Project: LFUCG PSOC

Subject: New Sill Flashing at Existing Penthouse Louvers

Change Order Proposal PR #46

MPE REQUEST FOR PROPOSAL

FLASHING AT EXISTING LOUVER

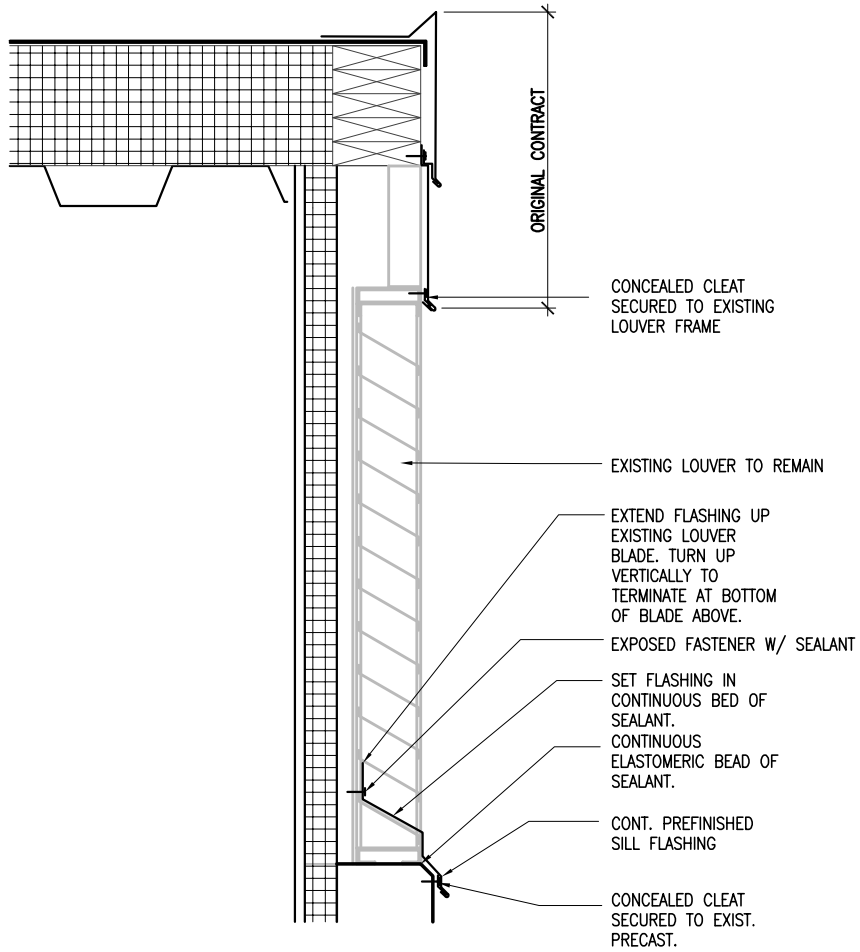
- Provide new metal sill flashing along the top surface of the bottom louver blade at each of the existing penthouse louvers. Extend the new flashing profile up the existing louver blade, and turn it vertically up to the bottom of the next blade above.

- Provide concealed cleat & fasteners at the bottom of the new sill flashing.
- Provide exposed fasteners through the new flashing into the existing louver assembly as close to the top edge of the new flashing as possible, to minimize its exposure to weather. Provide sealant closure at each exposed fastener.

- Provide a "corner flashing" piece on top of this new sill flashing at the 90 degree corners of penthouses, where the existing louver blades and the new sill flashing are mitered. This "cap flashing" is meant to flash that exposed miter joint at the corners.

- Provide a metal cover plate on top of each existing drilled or cut opening of various louver blades.
- Where former mechanical units (fans, etc.) have been removed from exterior faces of existing louvers, leaving gaps in continuity of the louver blades, provide new louver blade sections, matching profile of existing blades, as infill in these areas, overlapping adjacent louver blades by approximately 4".

RELOCATE AI PHONE
FROM VESTIBULE V100
ENTRY TO PEDESTRIAN
GATE

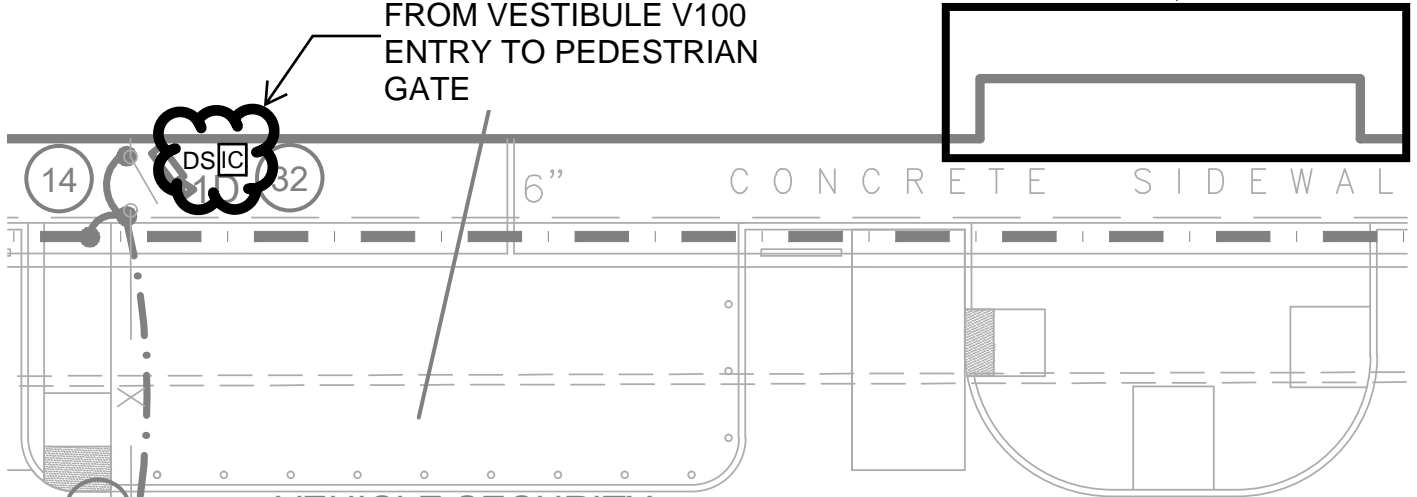
The Contractor shall provide a proposal to locate the AI Phone controller at the pedestrian gate as shown on Sketch XE05, in lieu of Vestibule 100V entrance as shown on the original Contract Documents. Exterior exposed wiring shall be in rigid conduit with the wall mounted AI Phone unit as depicted in Sketch XE05 (24" East of gate and 48" above finish sidewalk grade.)

Trigger wiring for gate control shall be routed back to the South West corner of Electrical Room 142 and terminated at the security access control panel to log activity. The Contractor shall also price furnishing and installing (1) additional (22/6 exterior) wire form each of the (2) gates to facilitate access controller communication.

Relocate the AI phone from Vestibule 100V to pedestrian gate per sketch XP04.
 Provide a stainless steel back box for the AI phone at new location.
 Provide conduit and wiring, also an additional 22/6 cable from gate controller.
 Price does not include any lightning arresters. None called for in Proposal request.

1. MCP Data Rack Layout

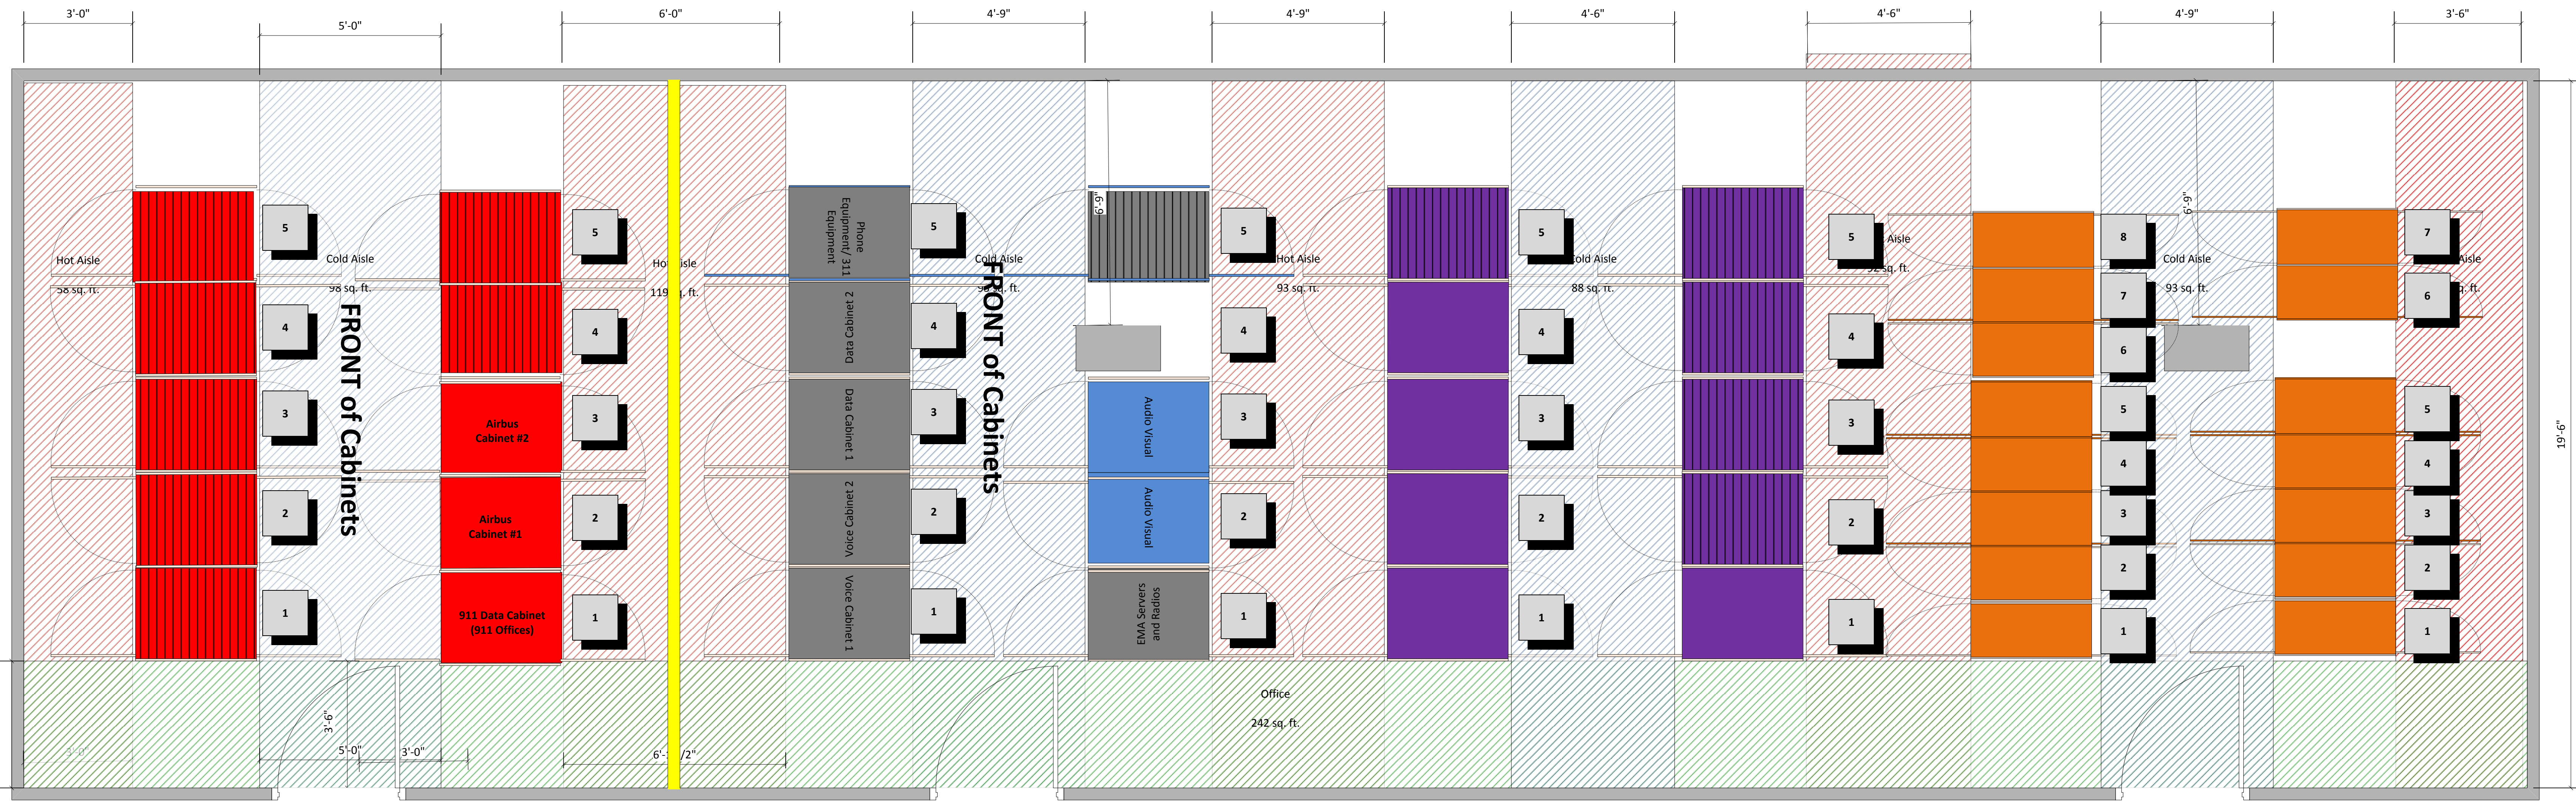
The Contractor shall provide a proposal to make the following changes and additions. The Owner requested that approximately 66 data drops located in rooms 148, 150, 153, 154, 155, 132, 138, 139, F101A, F101B, 143 and 144; be terminated in a separate Cabinet (provided by LFUCG) located on the west side of Room 140 located in Row 2 Cabinet 1 (See Attached Layout). Two patch panels are required for these terminations. Relocate one 48 port patch panel from the data cabinet that was previously serving the drops.

The Contractor shall furnish and install one (1) additional 48 port patch panel in the newly designated data rack. The Contractor shall install the Owner furnished rack as well as furnish and install the rack mounted ground bar (RGB) and grounding connections in accordance with Construction Note 16 on Drawing E1.7.

Voitress will provide materials, labor, and testing for the following, all as per PR 50:

Re-route 70 cables, as outlined in PR 50 to cabinet in second row of MDF (Room 140).

One new patch panel, wire manager, and ground bus will be furnished and mounted in cabinet. Attaching ground bus grounding wire by others.
